The Exchange Project

Final Environmental Impact Report

SCH#2018071058

2 Response to Comments

Exhibit 8-2 included in the Urban Crossroads TIA report dated November 30, 2018 (EIR Appendix L: Traffic Impact Assessment)

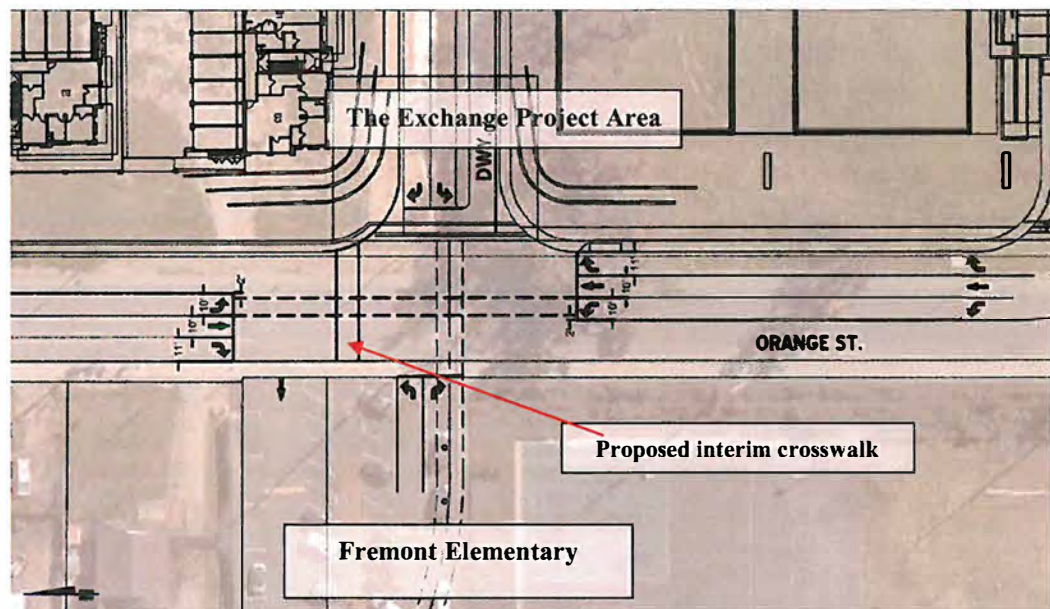
- a. The interim intersection layout has a proposed crosswalk aligning with the median of the existing Fremont parking lot. This will result in a significant safety hazard of students having to cross vehicle traffic on Orange Street and at either one of the two Fremont driveways to access the school's on-site walkways.

The interim layout, as proposed, does not comply with the Education or Mobility Elements of the City of Riverside General Plan 2025 for Safe Routes to Schools. City Policy CCM-8.2 is to promote walking and biking as a safe mode of travel for children attending local schools. CCM-8.3 is to apply traffic management

As stated in the TIA (included as Appendix L of the Draft EIR), the proposed project driveway has been designed and the impacts of the project were analyzed under the existing conditions presented in Exhibit 8-2 of the TIA, such that the project driveway aligns with the existing egress driveway of Fremont Elementary School. Should the school change the ingress/egress configuration in future, the TIA anticipated that a reasonable configuration would be one where the driveway would be pulled south to align with the crosswalk. The TIA clearly states that should such a future scenario occur, the recommendation is to maintain the northbound and southbound left turn lanes with a lead-lag (or lag-lead) operation, which would be the same as the current project design and intersection operation as detailed in Exhibit 8-2. The project applicant met with RUSD in early March 2019 to discuss and modify the ultimate design at Driveway 1 on Orange Street. A Public Works Condition has been included in the Conditions of Approval stating that discussions will be ongoing and any changes in configuration will be determined in coordination with the City traffic engineer and the District. As detailed in Response 3.3, any changes to the crosswalk layout and design would not change the level or service or traffic signal phasing. The intersection would comply with all safety requirements in the State Manual of Uniform Traffic Devices and would be reviewed and approved by the City's Traffic Engineer.

Exhibit 8-3, the “ultimate design” included in the Urban Crossroads TIA report dated November 30, 2018. Shows an alteration to Fremont’s parking lot that was never approved by RUSD.

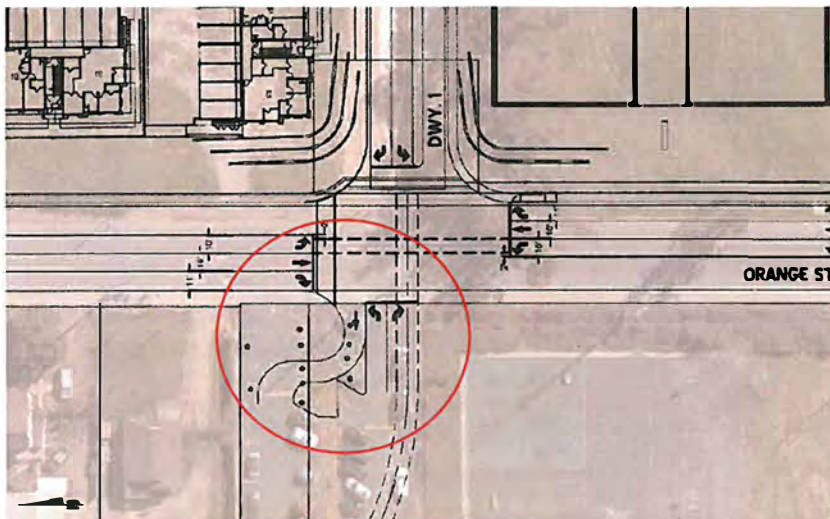
As stated in previous communications with the City and developer, this proposed driveway alteration must impose no financial responsibility to RUSD for the cost of the construction. RUSD has no plans to implement such a proposed alteration. It was RUSD's understanding that the ultimate layout would **not** be proposed to be implemented as part of the project. Therefore, it should not be utilized to conclude that the project will not have an impact. Any such proposed alteration must be planned and authorized with District Planning and Development staff prior to the Planning Commission meeting on March 21, 2019.

The commenter opines that the TIA conclusion is invalid because the ultimate intersection layout depicts the driveway at Fremont Elementary School that has not yet been approved by RUSD. The commenter states that RUSD currently has no plans to implement the proposed alteration of the school driveway (per Exhibit 8-3 of the TIA) and that no financial responsibility shall be placed on RUSD for the cost of construction.
